ADDRESS: 1133 & 1145 GRISWOLD

APPLICATION NO: #23-8236 & #23-8247

HISTORIC DISTRICT: CAPITOL PARK

SCOPE: RENOVATE FAÇADE, CONSTRUCT ROOFTOP ADDITION

1133 Griswold (left) and 1145 Griswold (right). Staff photo taken 2/28/2023 showing current conditions

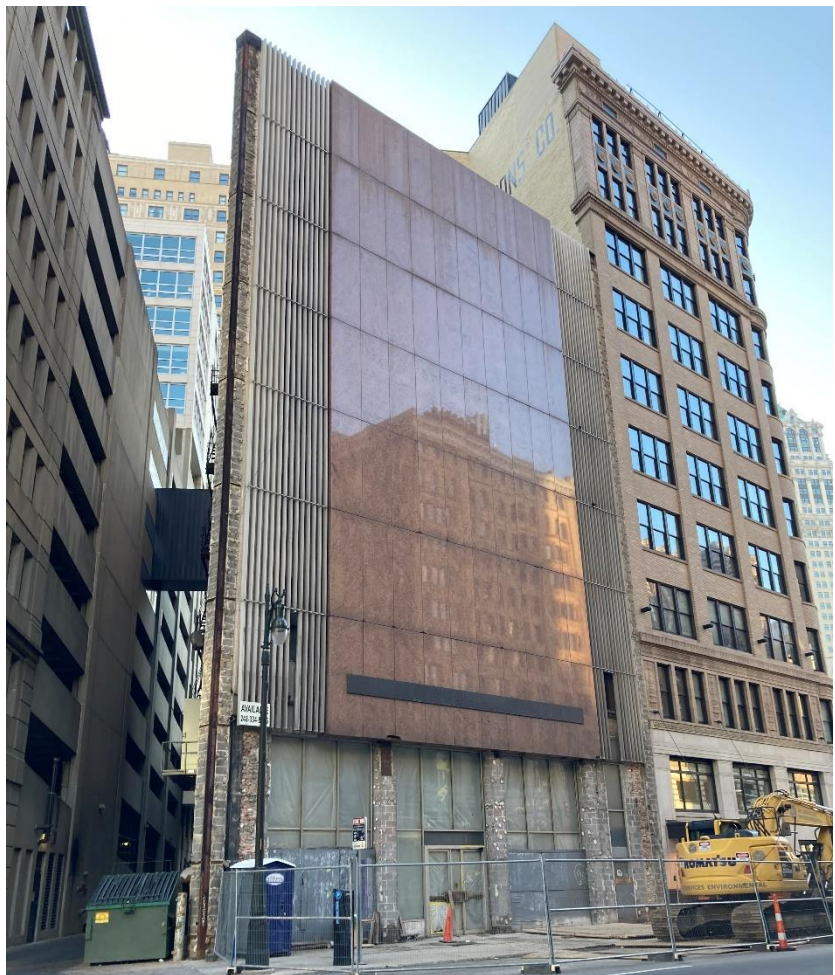
The building located at 1133 Griswold was built in 1921 and was designed by architect Albert Kahn. The building originally housed the United Savings Bank of Detroit. The 7-story building features pink granite, metal screening with marble panels beneath (installed in 1971) at the front/east elevation at stories 2-7. An aluminum storefront and concrete block columns are present at the first story, east /primary elevation. The south/alley-facing elevation is primarily clad with limestone, although at the easternmost bay, the exterior cladding has been removed, leaving the concrete block structure exposed. Double-hungx, wood windows are located at the south/alley-facing elevation. An historic-age, steel fire escape is also located at the south/alley facing elevation.

**Building in
1986 and
1999**

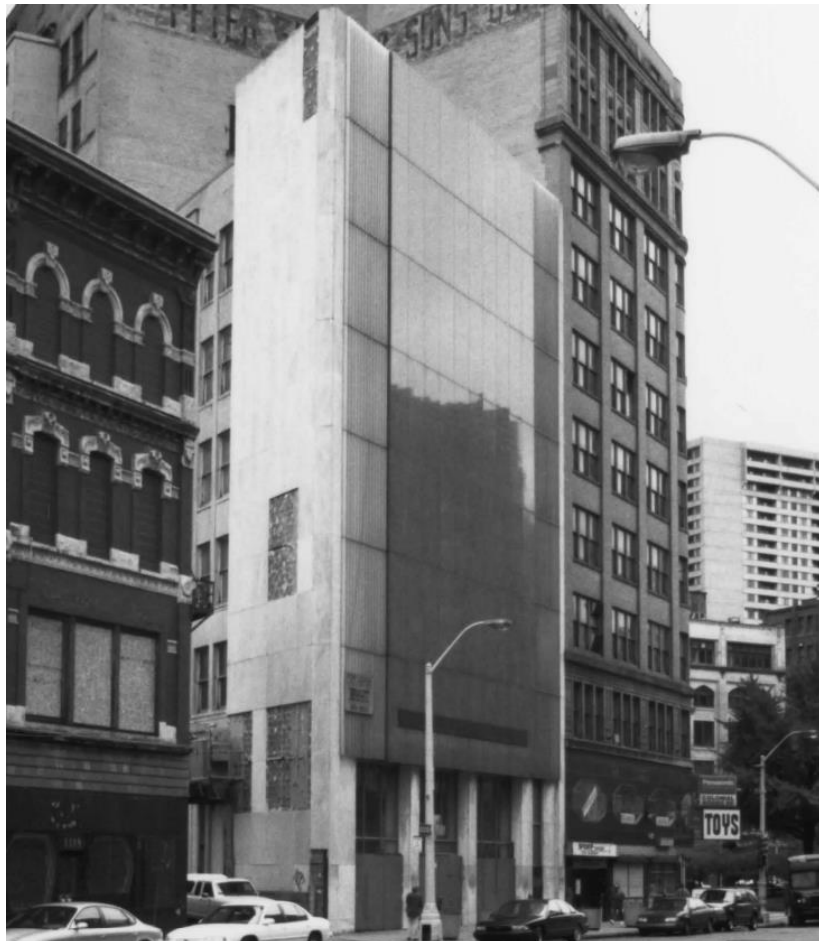
- Original wood windows, limestone cladding, and an historic-age steel fire escape remain at the building's south/alley-facing elevation. The most readily visible portion of this elevation is concrete block as marble cladding which had been installed at this location during the 1971 renovation was removed sometime before 2009.

- The 2012 HDAB designation identified the building as contributing to the district.
- It is staff's opinion that the building lacks the integrity of design, materials, workmanship, and feeling necessary to convey the building's significance as an early 20th century commercial building designed by a master (Albert Kahn) as the three renovation campaigns have resulted in the removal of much the building's original/1921 fabric. In no way does the building remain as recognizable to Kahn's original design/as a good example of Kahn's early 20th century commercial design. Please see the below photos. It is staff's opinion that the building no longer remains its 1970s slipcover /remains as a cohesive example of 1970s architectural design due to the removal of the marble panels. It is therefore staff's opinion that the building does not contribute to the district.

- As it is staff's opinion that the building does not contribute to the district, the current application should be evaluated based upon the proposed work's compatibility with the building's historic surrounds. It is staff's opinion that the project is generally compatible with the district's historic character.
- As it is staff's opinion that the building does not contribute to the district, the existing wood windows and fire escape are not distinctive character-defining features which must be
